UNITED STATES PATENT AND TRADEMARK OFFICE

Office Action Summary	Application No. 10/665,158	Applicant(s) TANIGUCHI, TORU	
	Examiner Charles E. Cooley	Art Unit 1723

NON-FINAL OFFICE ACTION

FIG.-1

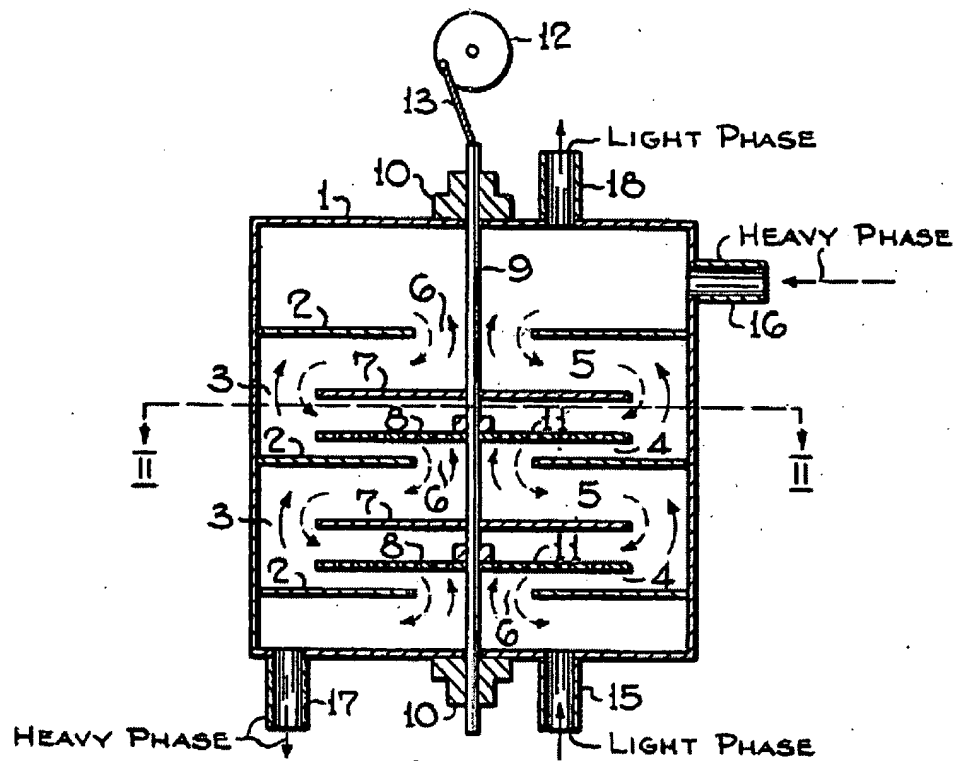
The patent to Fenske et al. discloses an agitation apparatus in Figs. 1-2 as seen below comprising a casing 1; agitation body with a shaft 9 connected to vibration source 12, 13; blades 7, 8 on the shaft with blades 8 being apertured at 11 - Fig. 2; openings 15-18 into the casing capable of being employed as either inlets and/or outlets; agitating chambers 4 separated by divider plates 2 along the length of the casing 1; the upper or the lower chamber (proximate 6 or 9 in Fig. 1) may be termed a pre-agitation chamber to which the openings 15, 17 or 16, 18 are attached; the blades inherently being capable of being changed - note the blades 7 and 8 are configured differently.

【図10】

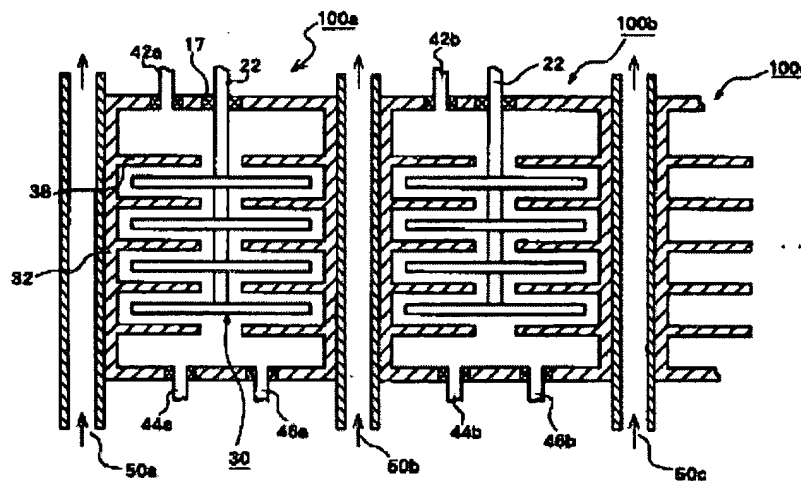
JP 2001-239140 discloses an agitation apparatus throughout the Figures including but not limited to the Figures seen below comprising a casing 100a or 100b or 32; agitation body with a shaft 22 connected to a vibration source (per the abstract); blades 30 or 34 on the shaft; openings 42a, 44a, 45a or 42b, 44b, 46b or 42-46 into the casing capable of being employed as either inlets and/or outlets (and note Fig. 23); agitating chambers separated by divider plates 38 along the length of the casing; the lower chamber may be termed a pre-agitation chamber to which the openings 44a, 45a or 44b, 46b or 44, 46 are attached; the blades inherently being capable of being changed.

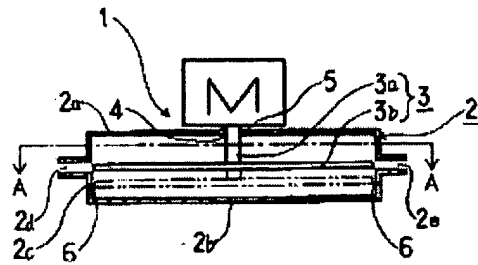
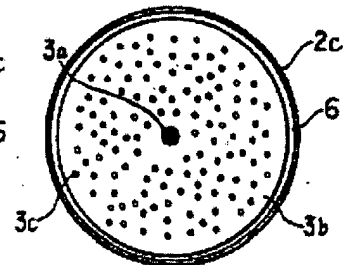
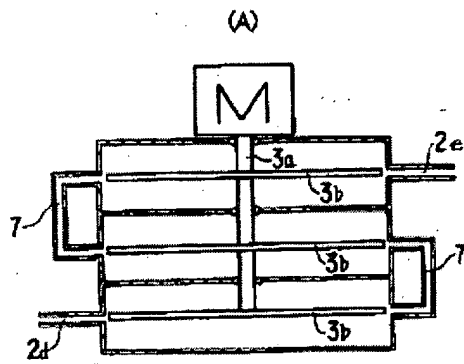
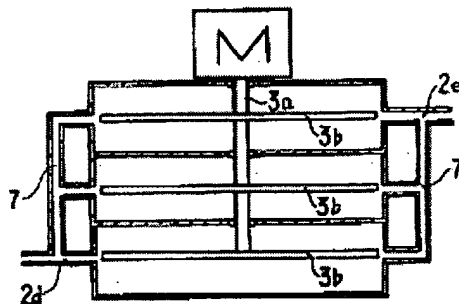
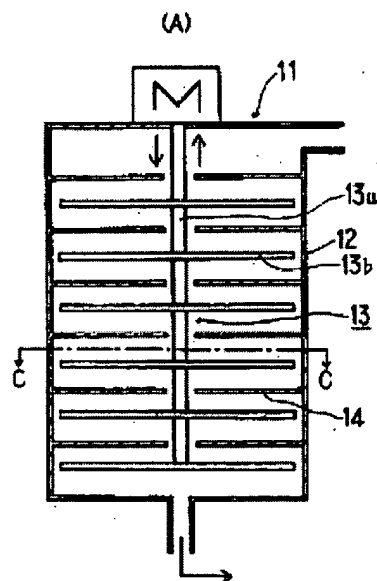
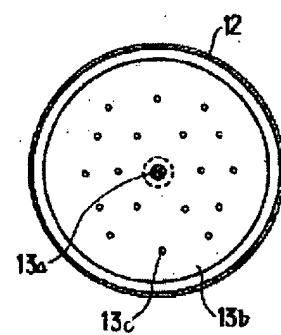
JP 11-169697 discloses an agitation apparatus throughout the Figures including but not limited to the Figures seen below comprising a casing 12; agitation body with a shaft 3a or 13a connected to a vibration source M; blades 3b or 13b on the shaft; openings 2d, 2e, 7 into the casing capable of being employed as either inlets and/or outlets; agitating chambers separated by divider plates along the length of the casing as seen in the Figures; the upper or lower chamber may be termed a pre-agitation chamber to which the openings 2e, 7 or 2d, 7 are attached; the blades inherently being capable of being changed.

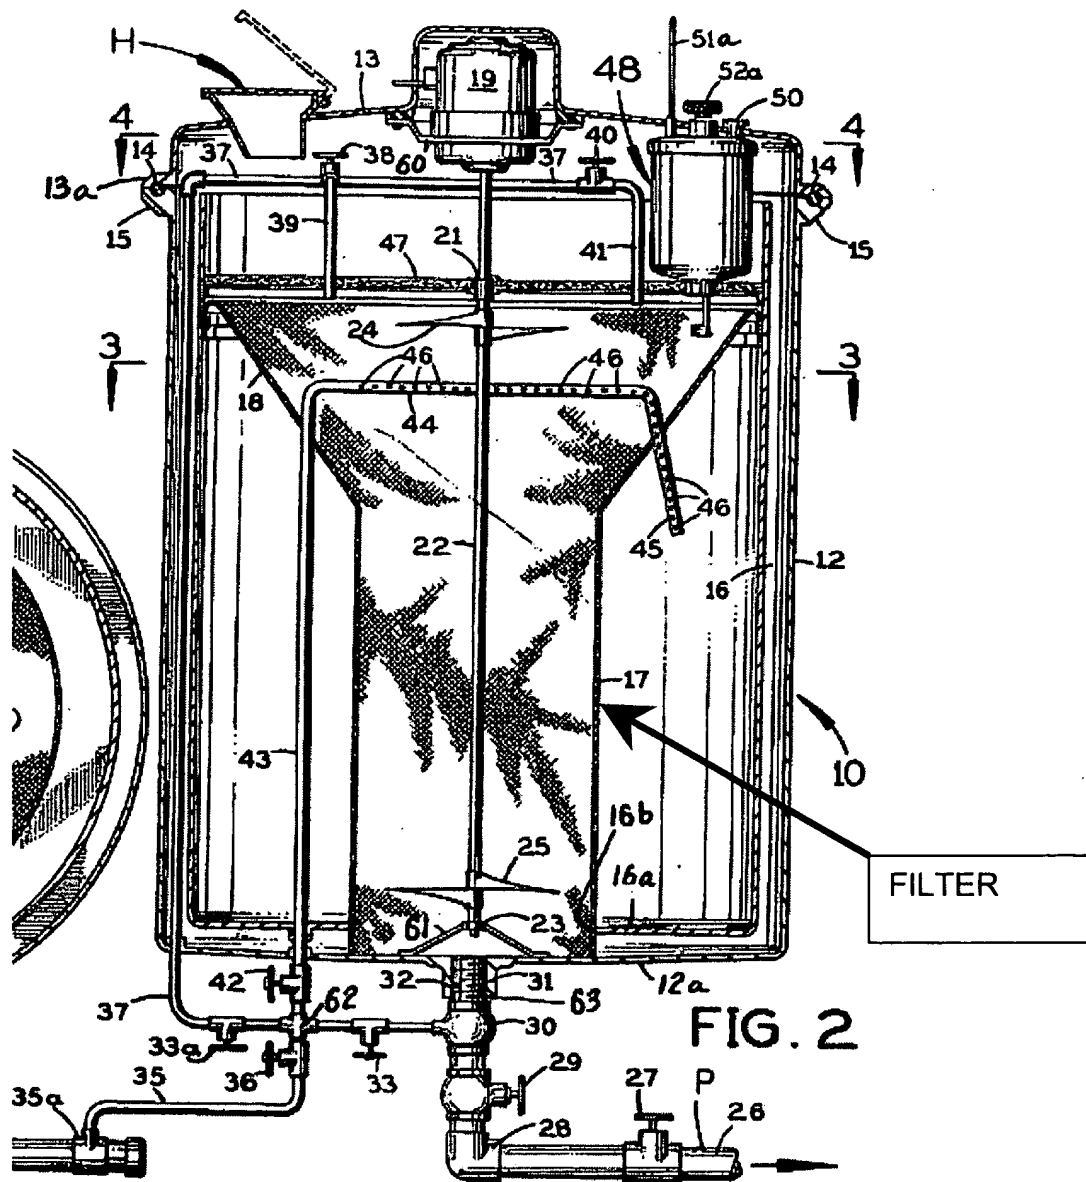
Fenske et al. (US 2,667,407), JP 2001-239140 or JP 11-169697 do not disclose a filter enclosing the agitation body. The patent to King discloses a casing 12 having an agitating body with a shaft 22 and blade 25 thereon wherein the agitation body is enclosed by a filter 17. It would have been obvious to one having ordinary skill in the art, at the time applicant's invention was made, to have provided the casings of Fenske et al. (US 2,667,407), JP 2001-239140 or JP 11-169697 with a filter therein enclosing the agitation body as disclosed by King for the purpose of preventing undissolved solids from passing therethrough (col. 4, lines 62-65).
